ADDENDUM NO. CC-1

RAYMOND CENTRAL PUBLIC SCHOOLS  
RAYMOND CENTRAL JR. & SR. HIGH SCHOOL ADDITION  
RAYMOND, NEBRASKA  
DLR GROUP PROJECT NO. 10-16113-00

COMBINED CONTRACT

August 12, 2016

# SITE GRADING AND DRAINAGE PLAN RAYMOND CENTRAL JR. & SR. HIGH SCHOOL ADDITION

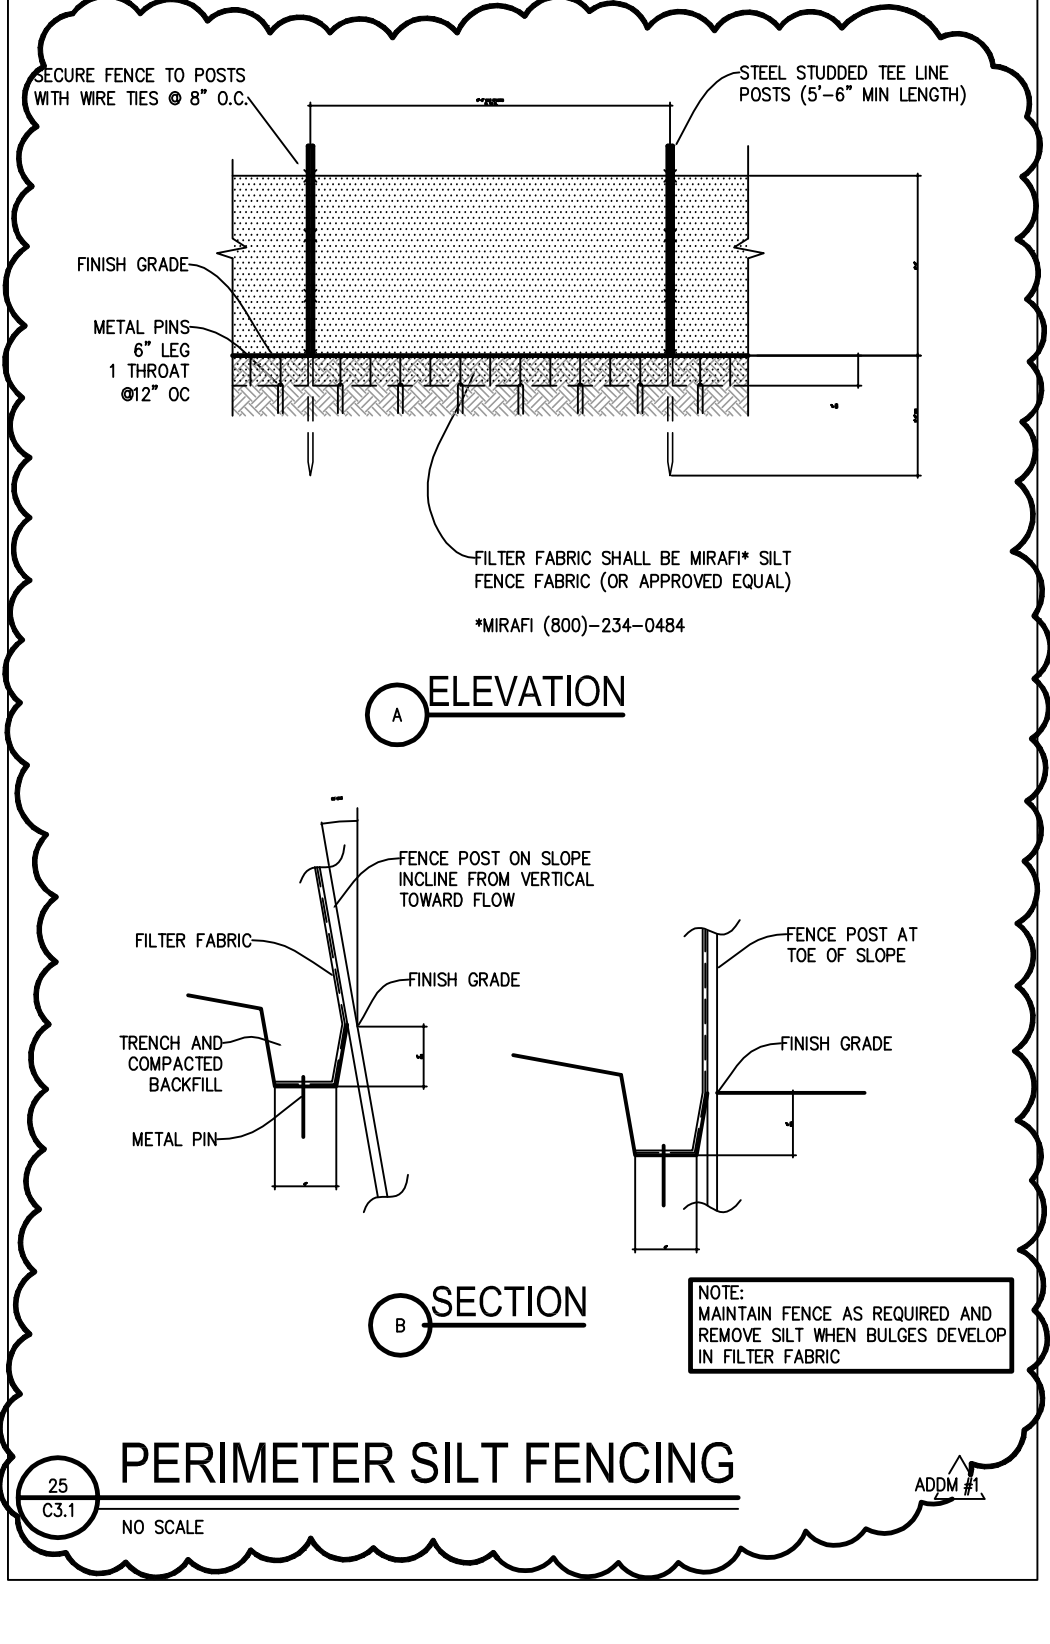
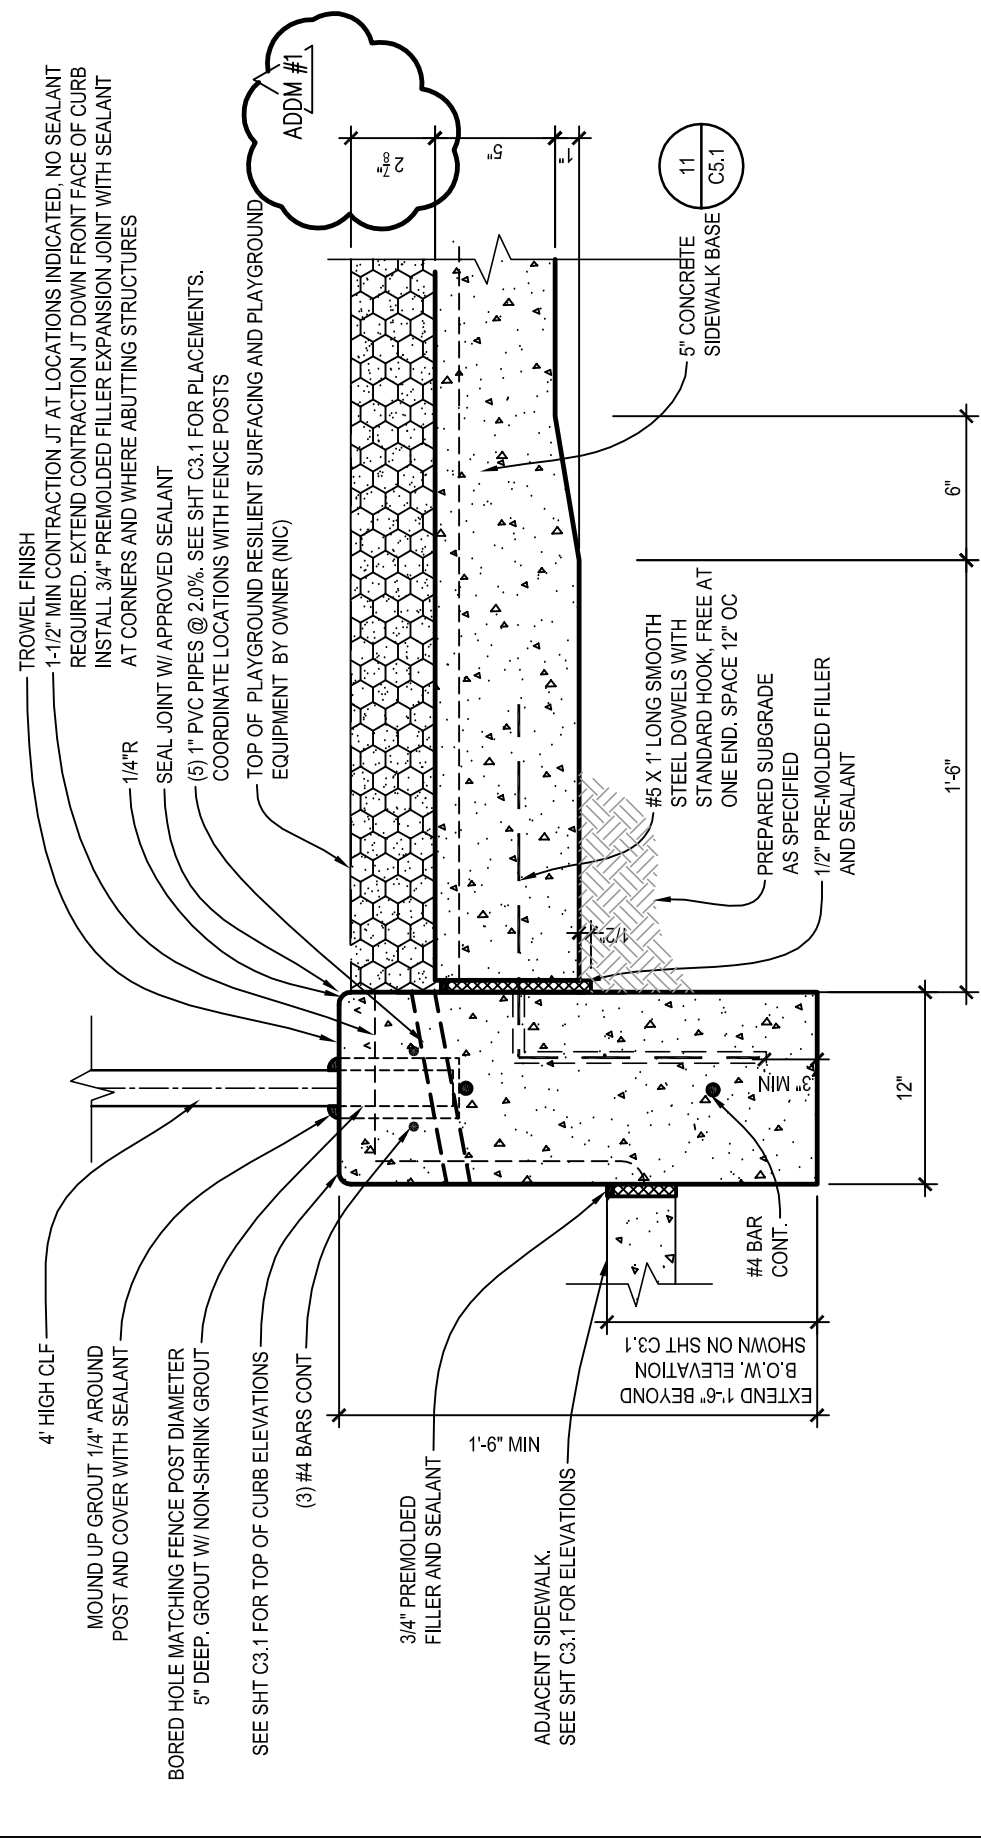
ITEM NO. 3 DRAWING C3.1 SITE GRADING AND DRAINAGE PLAN

- A. Delete Drawing in its entirety and substitute new Drawing C3.1 as shown on Attachment C3.1-1.

## SITE IMPROVEMENT DETAILS

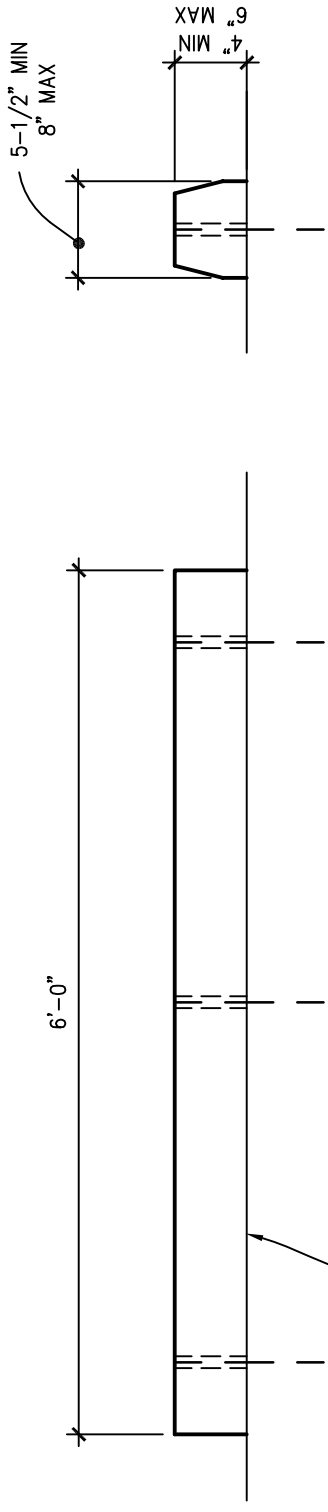
ITEM NO. 4 DRAWING C5.1 SITE IMPROVEMENT DETAILS

- A. Modify drawing as shown on attachment C5.1-1 dated 08-12-2016.

**FLOOR PLAN, FIRST LEVEL - AREA A**  
**RAYMOND CENTRAL JR. & SR. HIGH SCHOOL**  
**ADDITION**

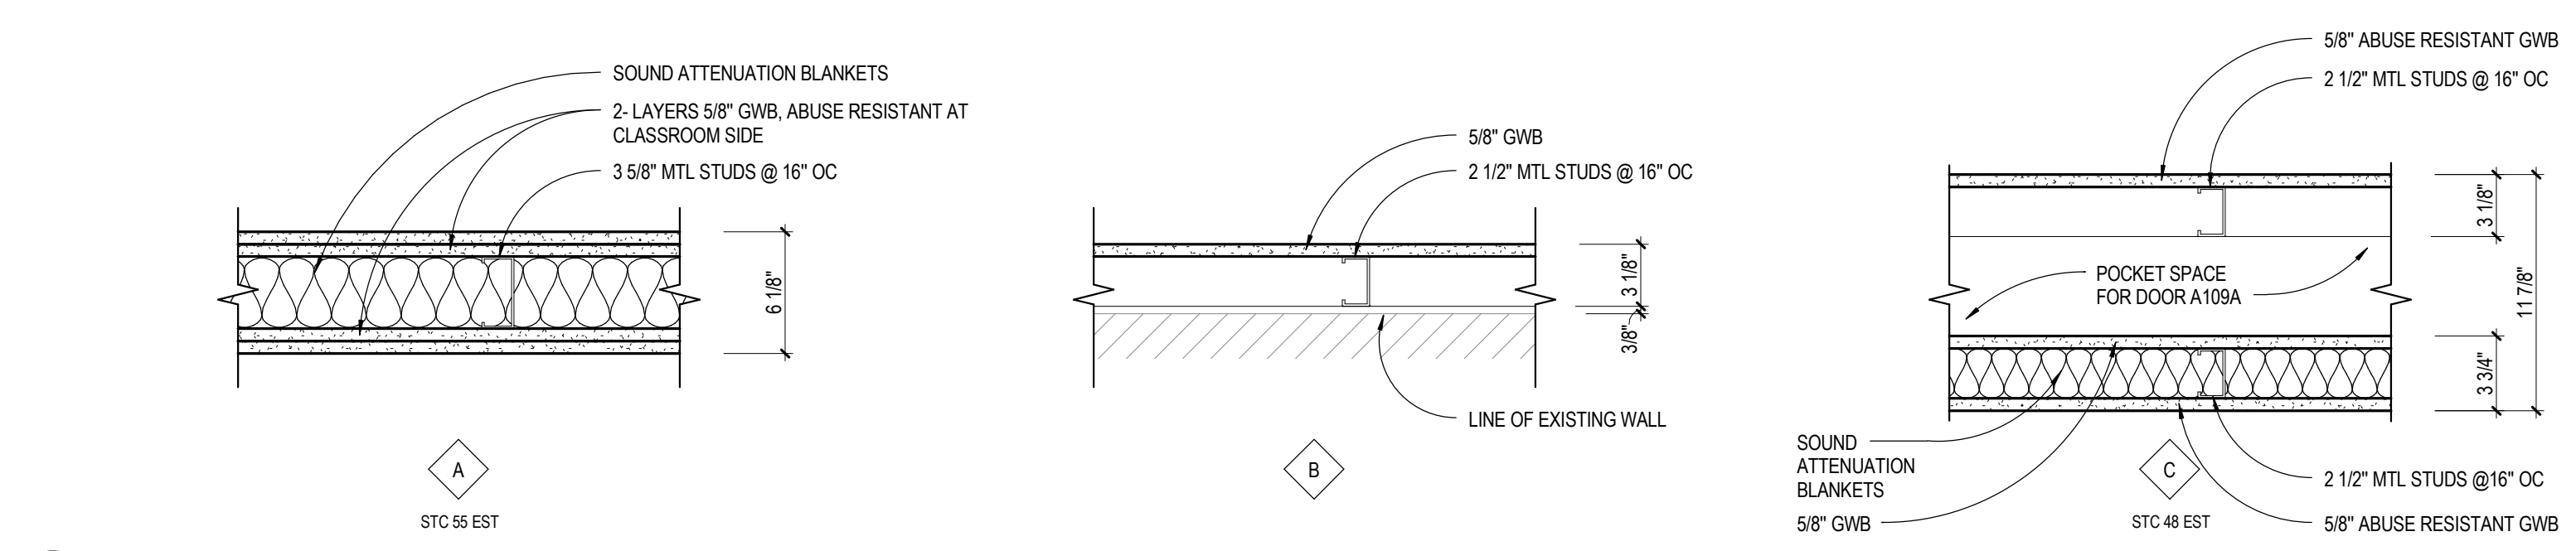
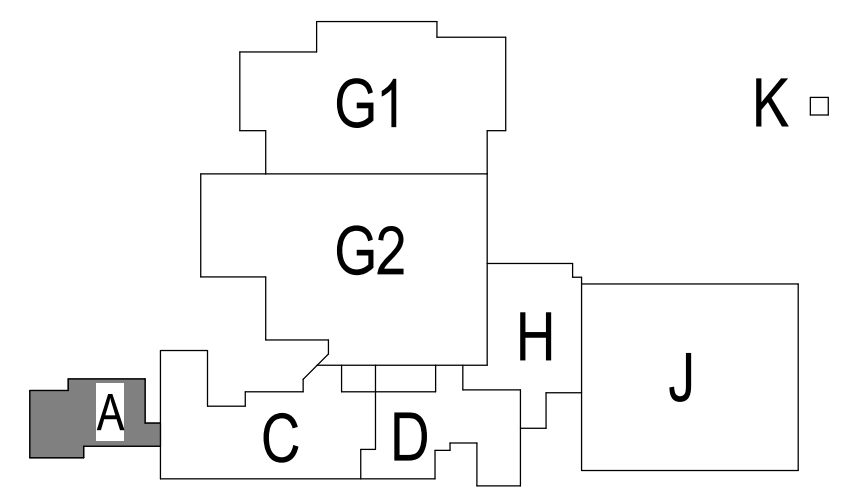
ITEM NO. 6 DRAWING A1.1 FLOOR PLAN FIRST LEVEL – AREA A

- A. Delete Drawing in its entirety and substitute new Drawing A1.1 as shown on Attachment A1.1-1.
